FORMAL ADA/PROWAG CIVIL RIGHTS GRIEVANCE

City of Bloomington, Indiana

717 S. Henderson Street — Removal of Accessible Pedestrian Route During Redevelopment; Failure of ADA/PROWAG Review in Planning, Permitting, Construction, and Complaint-Intake Process

Re: ADA / PROWAG Non-Compliance — Removal of Accessible Pedestrian Route, 717 S. Henderson Street; Failure to Provide Accessible Alternate Route During Construction; Failure of ADA/PROWAG Review and Complaint-Routing Process

Fig. 2: Google Street View imagery dated May 2019, 717 S. Henderson on right.

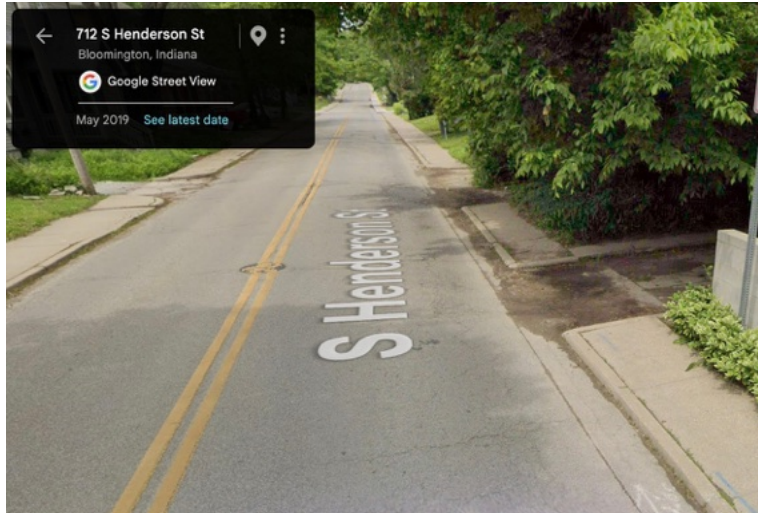
The complainant's understanding of the history of this frontage, based on available Google Street View imagery and direct observation, is as follows. In approximately 2017, and as late as May 2019, the sidewalk condition in this area was discontinuous and did not provide a continuous accessible pedestrian route (Fig. 2). At some point after 2019, and before the 717 S. Henderson redevelopment began, the City or a prior property owner improved the frontage to provide a continuous, direct, paved concrete pedestrian route. Google Maps Street View imagery dated April 2026 — captured after redevelopment had begun but before the sidewalk was relocated — shows that a continuous concrete sidewalk ran in a straight line along this frontage and that the alley crossing was paved at that time (Fig. 3).

This sequence matters because it establishes that the City had already moved this location toward accessibility compliance by the time the 717 S. Henderson redevelopment began. The redevelopment did not occur at a location where no accessible route had ever existed; it occurred at a location where a continuous accessible route already existed and was then interrupted and replaced by a substantially worse condition.
